Our Case Number: ABP-314724-22

Re: Railway (Metrolink - Estuary to Charlemont via Dublin Airport) Order [2022]
Metrolink. Estuary through Swords, Dublin Airport, Ballymun, Glasnevin and City Centre to
Charlemont, Co. Dublin

**RE: SUBMISSION ON THE METROLINK RAILWAY ORDER APPLICATION IN
RELATION TO THE SITE OF A COMMERCIAL DEVELOPMENT AT 2 GRAND
PARADE, RANELAGH, DUBLIN 6.**

**RAILWAY (METROLINK-ESTUARY TO CHARLEMONT VIA DUBLIN AIRPORT)
ORDER 2022**

Figure 1: Drawing submitted by TII to the Oral Hearing showing staircase/lift design

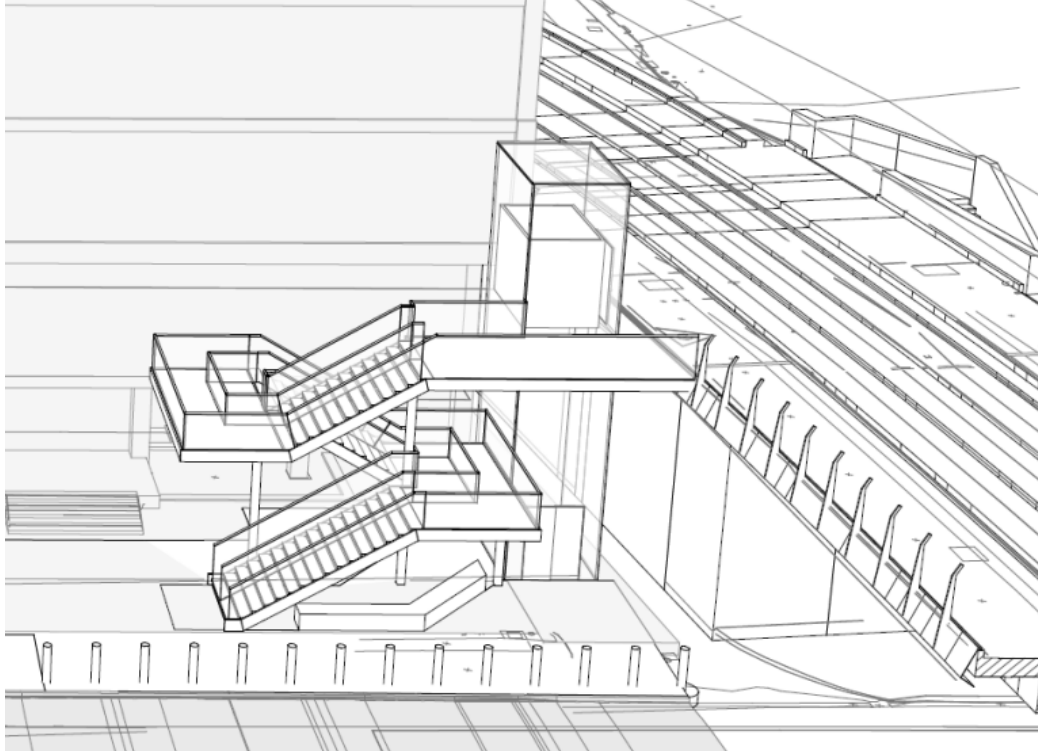
The updated information submitted to the Oral Hearing by TII included revised drawings, schematics, and visualisations of the proposed lift and staircase. It is considered that these details further illustrate the conflict between the design of this connection and the existing protected structure on site, which features extensive glazing that would be directly adjacent to the proposed public stairway and lift.

It is respectfully submitted that the provision of both a lift and staircase at this location cannot adequately achieve both an acceptable level of visual impact on the protected structure and its front setting (which has been restored as part of refurbishment works to include upgraded landscape treatment and the restoration of water features), while also ensuring that there is not a significant impact on the privacy of the building. The design proposals indicated in the updated drawings and imagery submitted to the Hearing indicate glass balustrades on the

stairway, with pedestrians traversing the stairs within c. 1-2 metres of work spaces within the building.

The transparency of the 2 Grand Parade protected structure, and the importance of views of the building 'in the round' were afforded a high degree of priority by the Board in the original application for its refurbishment and extension (Reg. Ref.: 2372/17 / ABP Ref.: 300873-18), with the applicants required to redesign the now completed office scheme to step away from the protected structure. The location of a lift and staircase in such close proximity to the architecturally important front façade would not be in keeping with this approach.

The design and location of this stairs and lift remains unacceptable to our client, and it is requested that revisions are made to this aspect of the design prior to the granting of any Railway Order, by condition or otherwise.

Figure 2: Updated photomontage submitted to the Oral Hearing

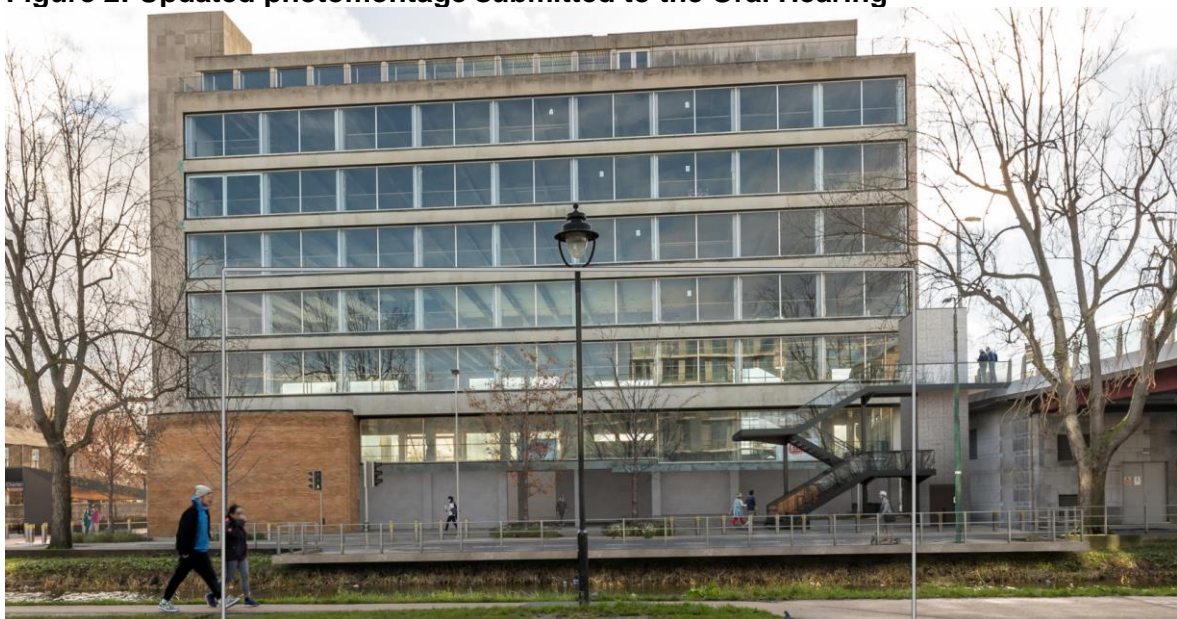
The updated photomontages submitted to the Hearing further illustrate the incongruous relationship between the proposed lift and stairway and the existing protected structure. The photomontages also do not reflect the quality or detail of the undercroft / entrance area of the 2 Grand Parade building (likely due to the fact that base imagery was taken while hoarding remained in place around the building). The stairway and lift would have a detrimental impact on the setting of the main entrance, along with the curtilage and hard landscaping of the building, including the restored water features.

Fig 2.1A Submission Drawing ML1-JAI-ARD-ROUT_XX-DR-Y-02090

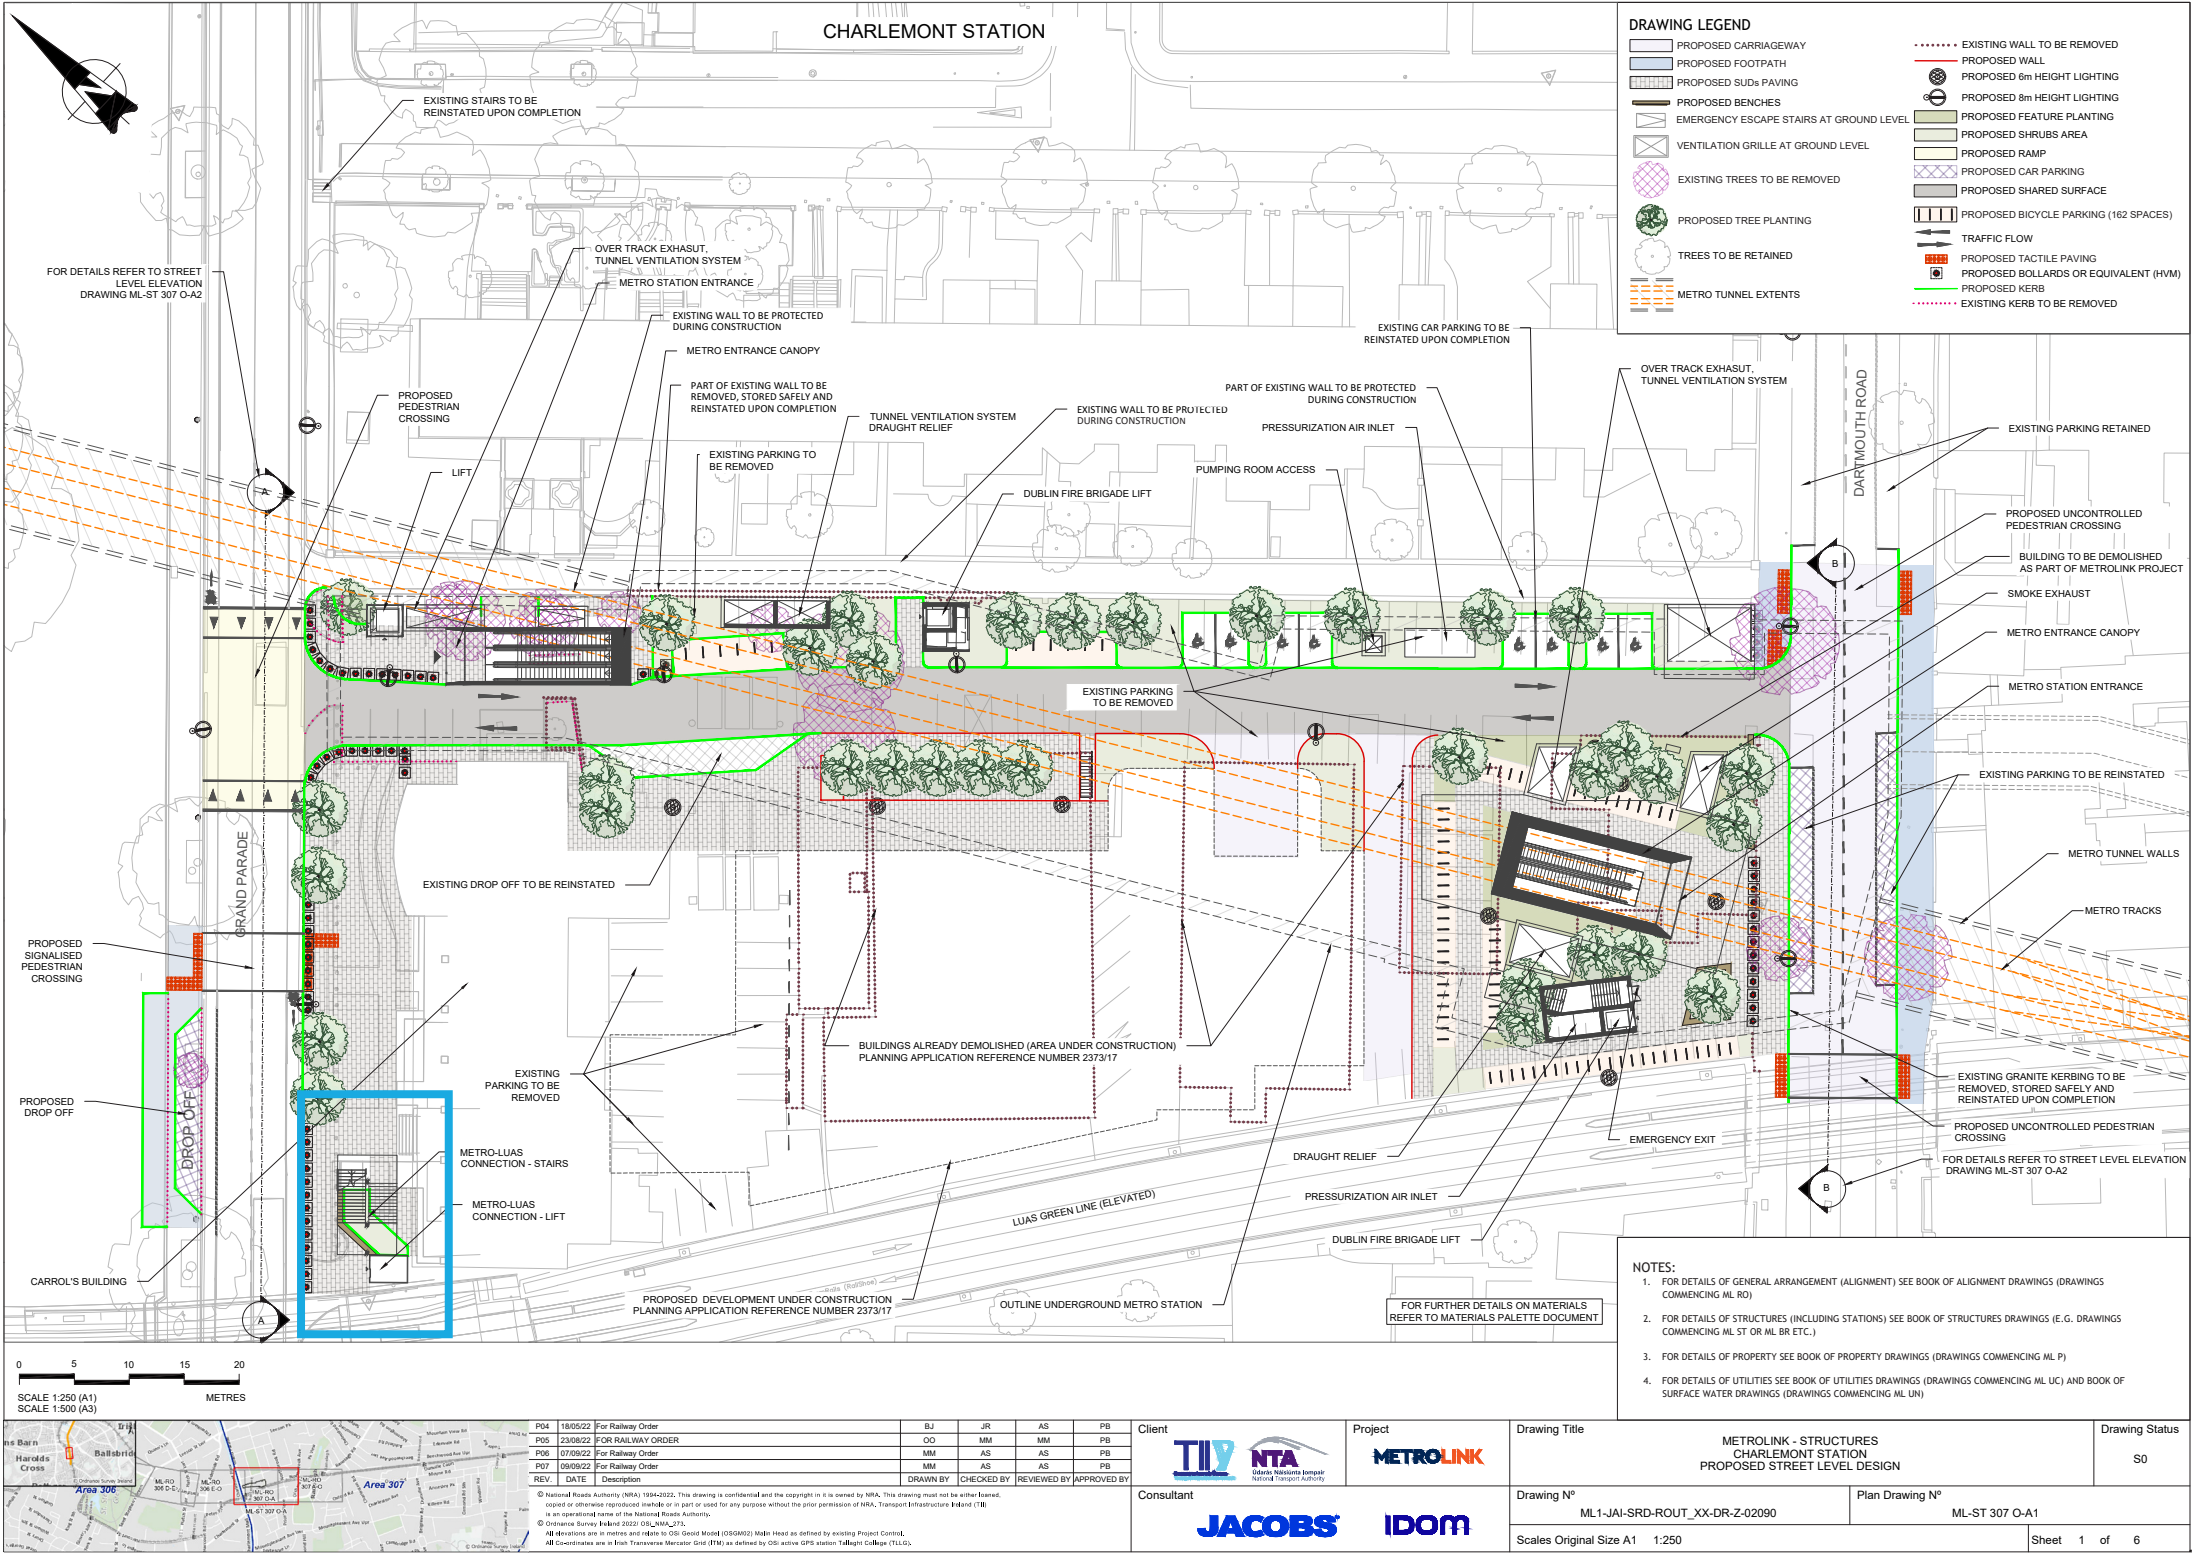
To provide context for this submission, the relevant Railway Order plan and elevation submission drawings are included with the proposed MetroLink stair and lift interchange outlined in blue.

To provide additional context of the impact to protected structure and for the building as viewed in the round, we have prepared selected 3d sketch views and plans incorporating the proposed stair and lift interchange.

Fig 2.1E Sketch plan at street level with interchange

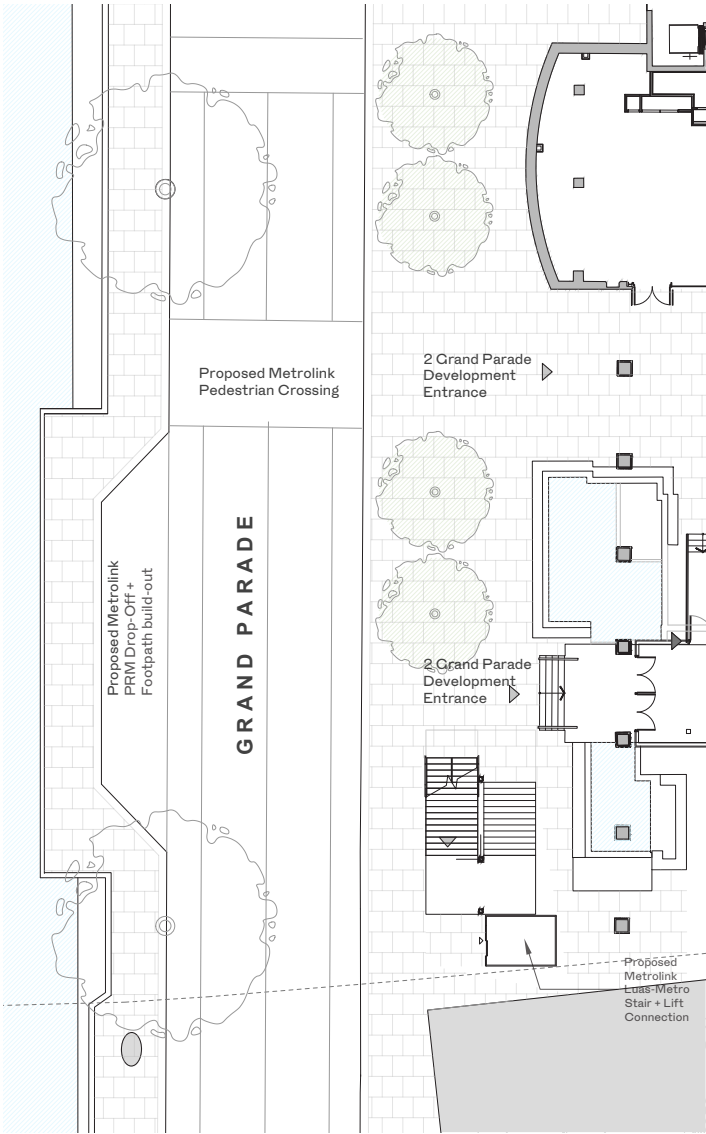
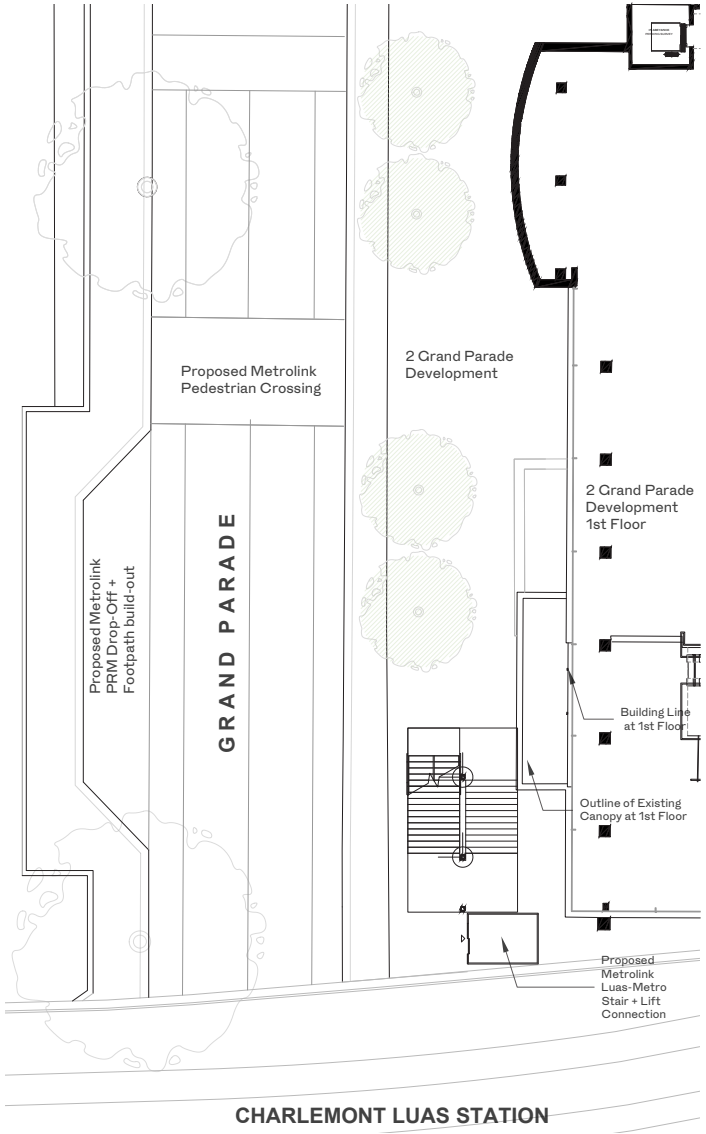
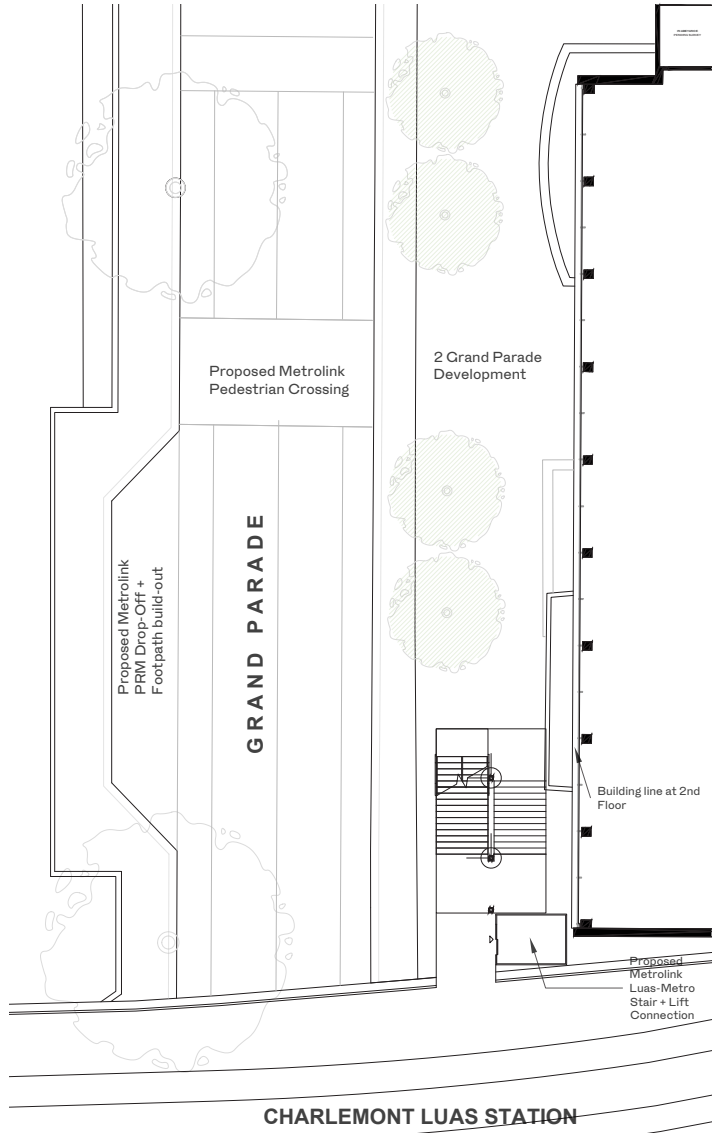
Refer to Figures 2.1E, F & G for ground, first and second floor sketch plans that demonstrate the proximity of the proposed interchange to the protected structure.

Fig 2.2A Extract from Report Ref. ML1-JAI-TRA-MS16_XX-RP-Y-00004| P01.2

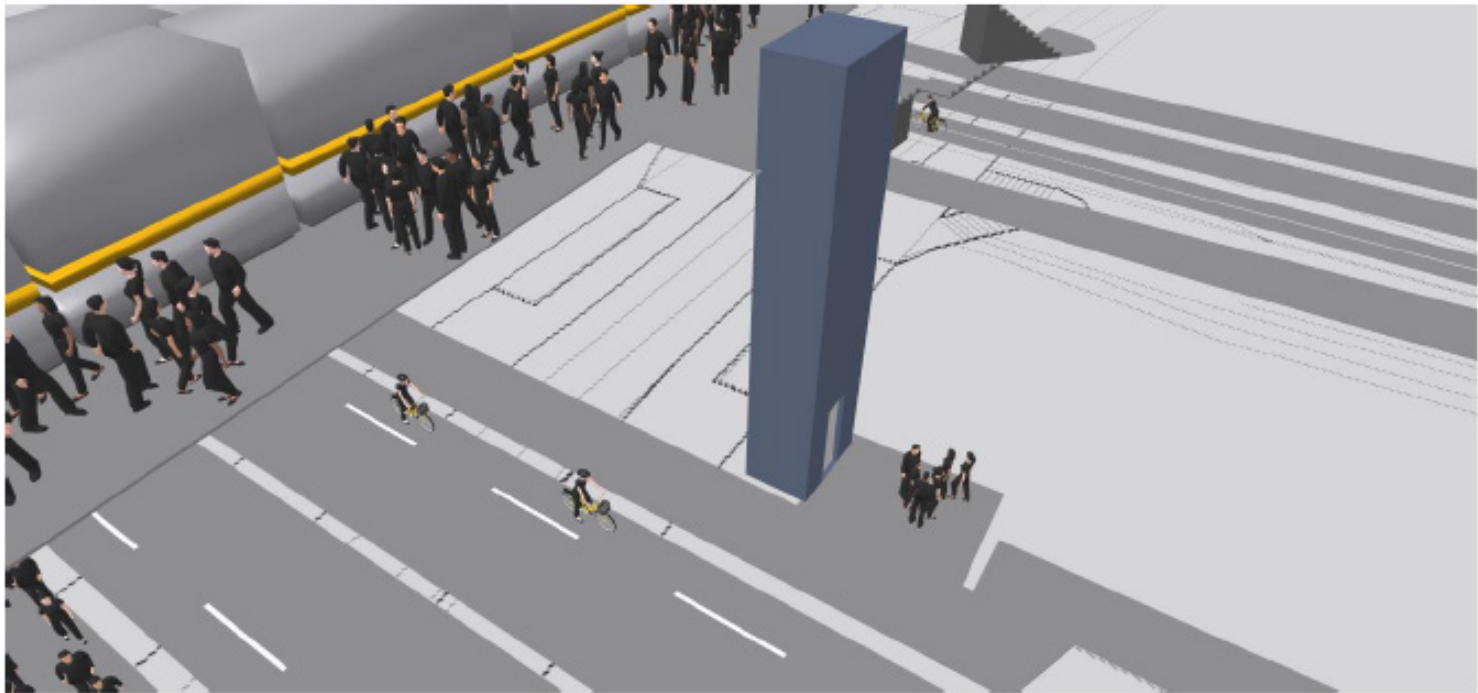
Refer to Figure 2.2A which is an extract from the report for this option that locates a through lift on the north side of Grand Parade.

This option would provide the opportunity to reduce the impact of the interchange and allow for the repositioning of the stair away from the main entrance and facade of the protected structure.
